SERVICE INSTRUCTIONS

REFERENCE: UPS-202301_A

SUBJECT: Smart Tachograph V2 Replacement for FMAX and Legacy Vehicles with ADR

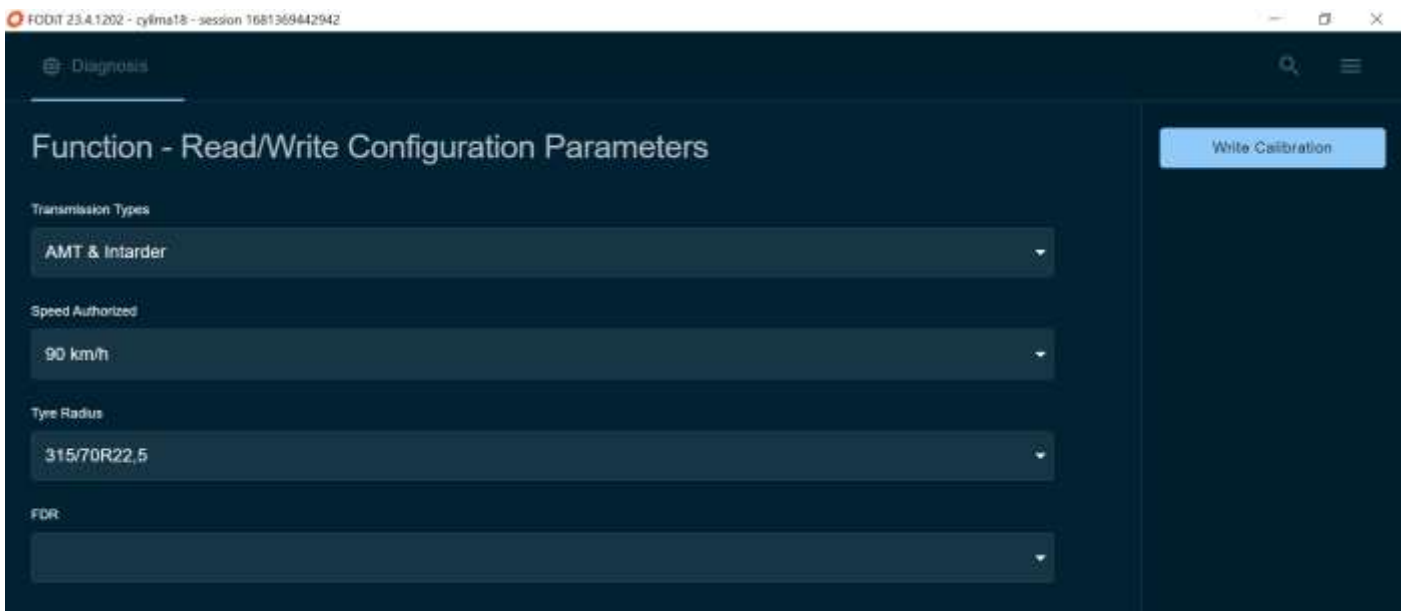
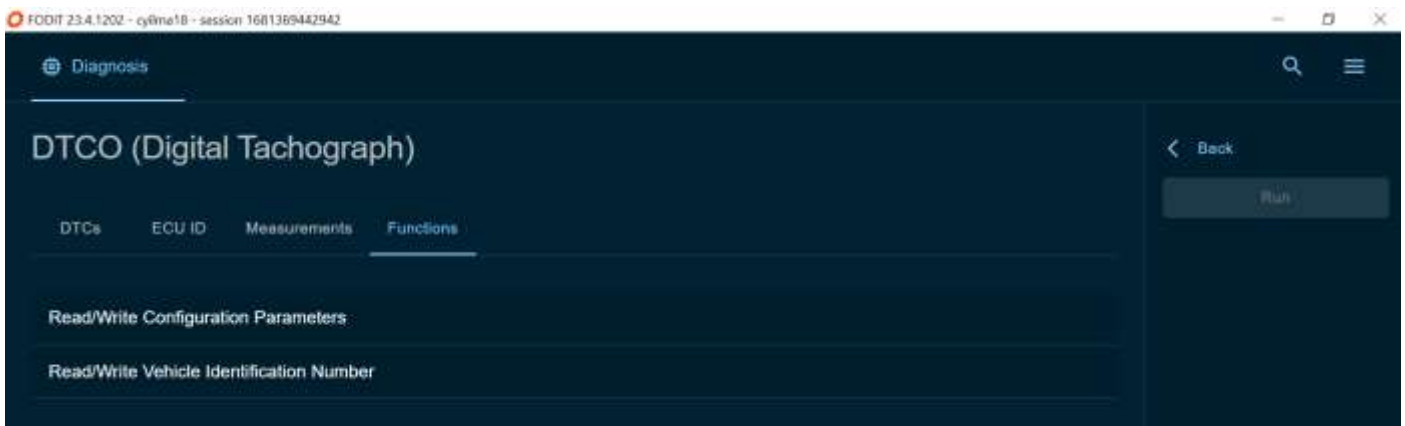
For replacement of the smart tachograph from DTCO 4.0 to DTCO 4.1 on FMAX and Legacy vehicles, the following changes must be applied:

- In FMAX vehicles, the tachograph is located in the upper storage area, and in the Legacy vehicles the tachograph is located on the right console.
 - **Location of Tachograph in FMAX;**

- **Location of Tachograph in Legacy;**

- The old version DTCO 4.0 tachograph should be removed from its place with the help of tachograph rods.
